Display

Subject: **WHITE BALANCE DRIFT**

Model: **BVM-D24E1WE, BVM-D24E1WU  
 BVM-D32E1WE, BVM-D32E1WU**

Figure 1

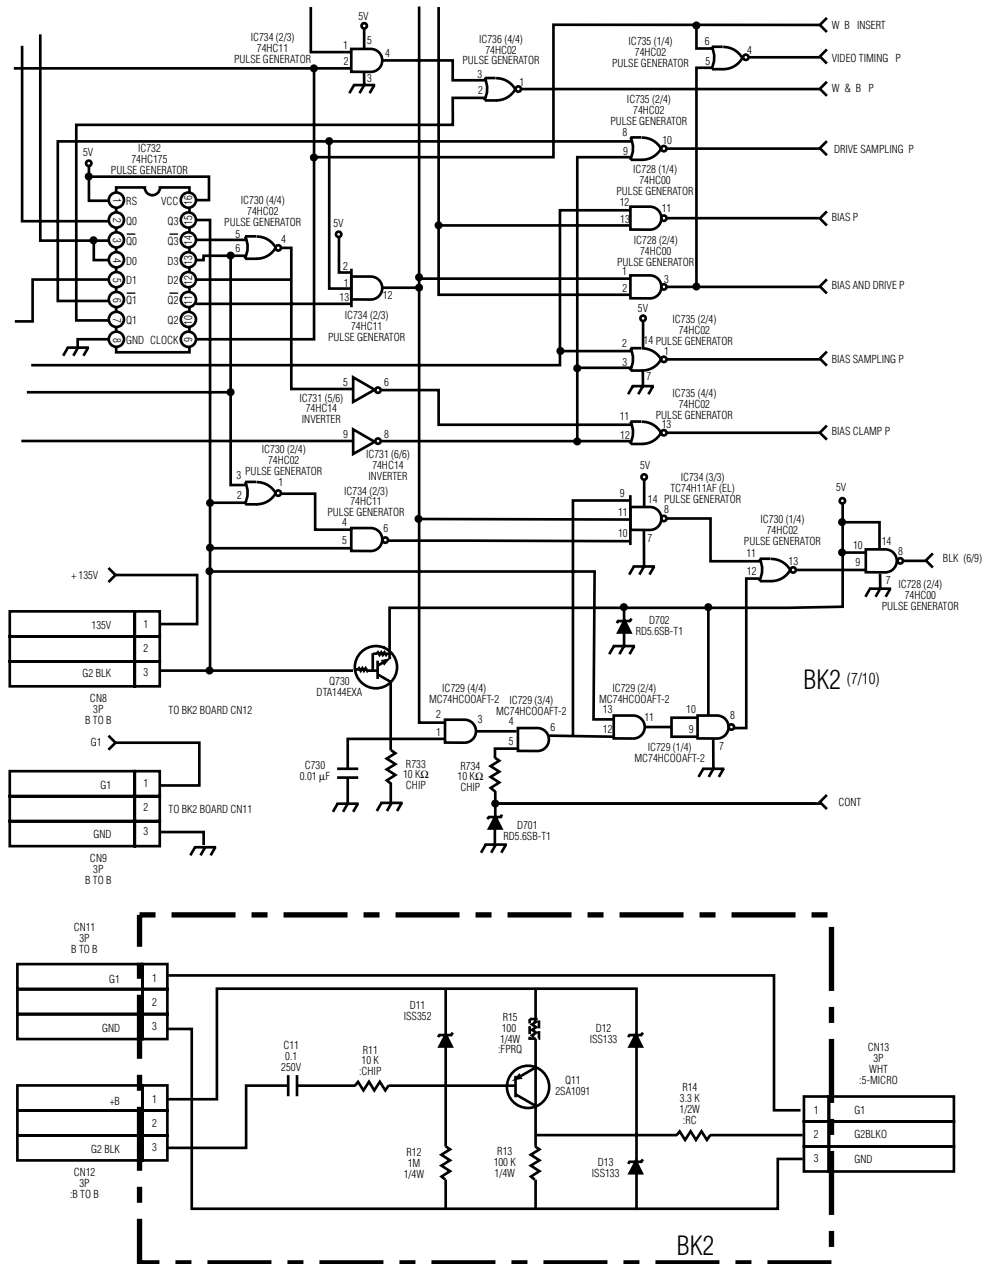
1. Replace the former BK board with a new BK board.

**NOTE:** Before replacing the former BK board, make note of the G2 REF value. The same G2 REF value must be entered in the new BK board as described in step 2b under the Confirmation heading.

- Former and new boards are not compatible. Use BK boards with suffix -B or later in combination with C boards with suffix -B or later. No picture displays if boards are used in incorrect combinations.
- See Figures 1 and 2 for schematic board changes.

Figure 2

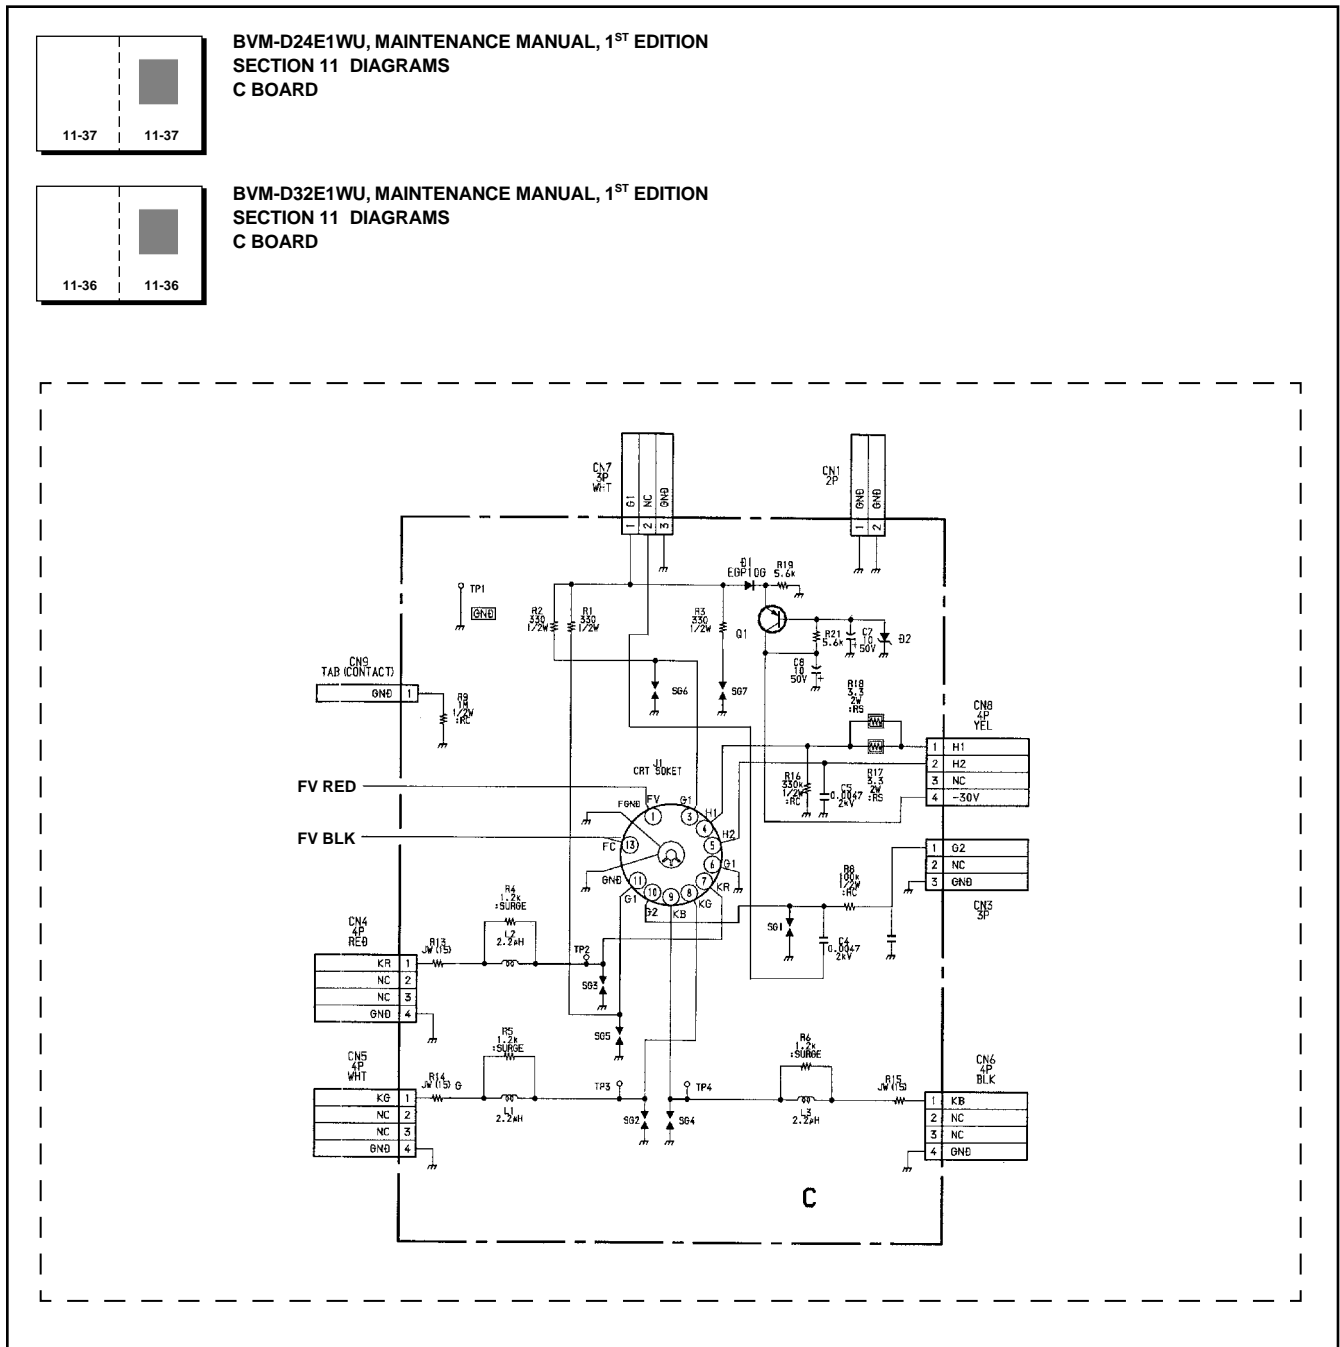
2. Replace the former C board with a new C board.
